PRODUCT / PROCESS CHANGE NOTIFICATION

1.1 Company	 STMicroelectronics International N.V
1.2 PCN No.	MDG/24/14536
1.3 Title of PCN	JSCC(China) UFQFPN 5X5 32L, UFQFPN 7X7 48L and VFQFPN 8X8 68L new BOM for STM32H50x & STM32H56x/H57x listed product .
1.4 Product Category	STM32H503xx, STM32H562xx, STM32H563xx & STM32H573xx
1.5 Issue date	2024-04-04

PCN14536 – Additional information

**JSCC(China) UFQFPN 5X5 32L, UFQFPN 7X7 48L and VFQFPN
8X8 68L new BOM for STM32H50x & STM32H56x/H57x listed
product.**

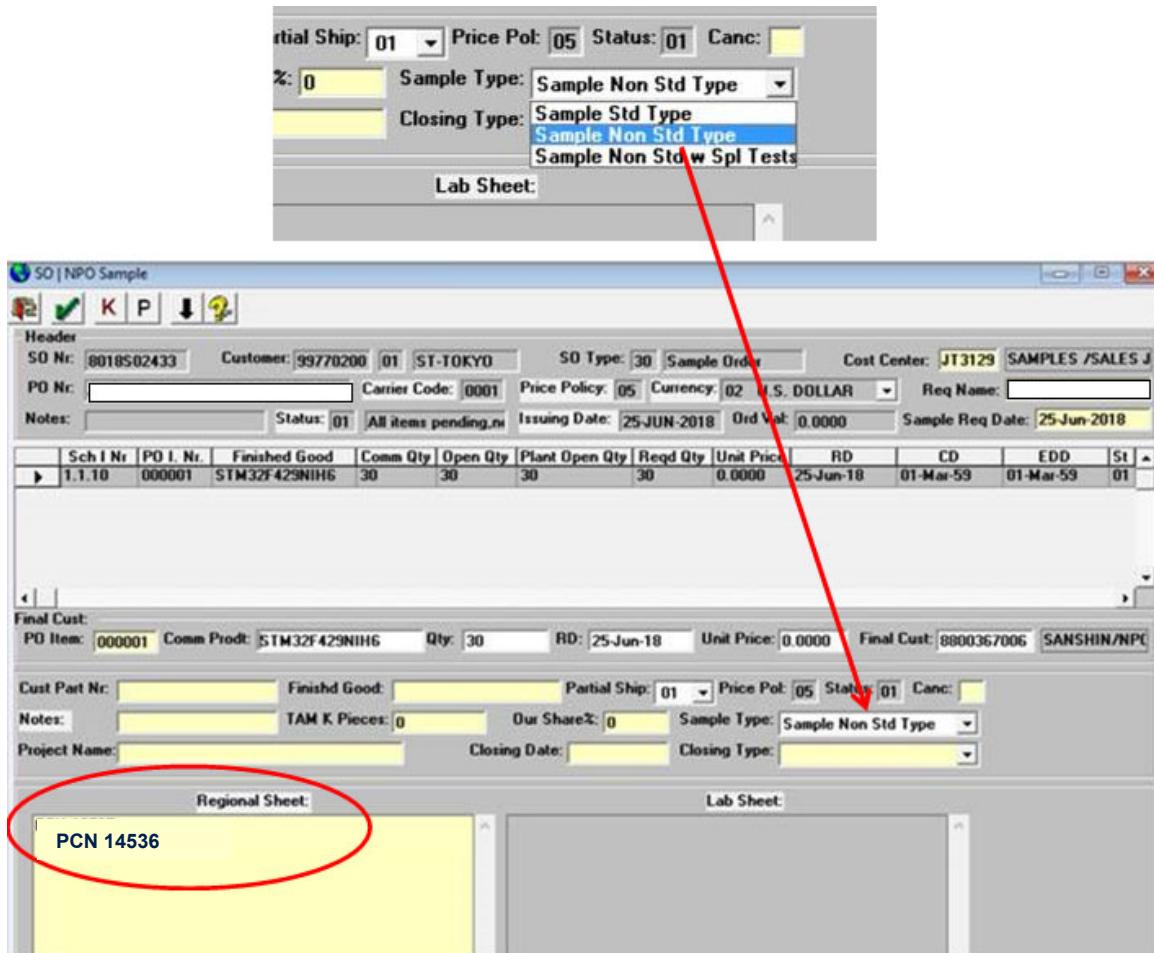
Assembly site	Existing back-end assembly line	New assembly line
StatsChipPAC JSCC Jiangyin China		
package	UFQFPN 5x5 / 7x7	VFQFPN 8x8
Lead frame	Standard Copper Frame Ag Plating	
Molding compound ⁽¹⁾	SUMITOMO G770	
Wire bonding	Gold 0.8Mils	
	CuPd 0.8Mils

⁽¹⁾ Package darkness might change depending on molding compound. The visual aspect (color) might change depending on substrate material. Marking position and size could be different upon assembly site, without any loss of information.
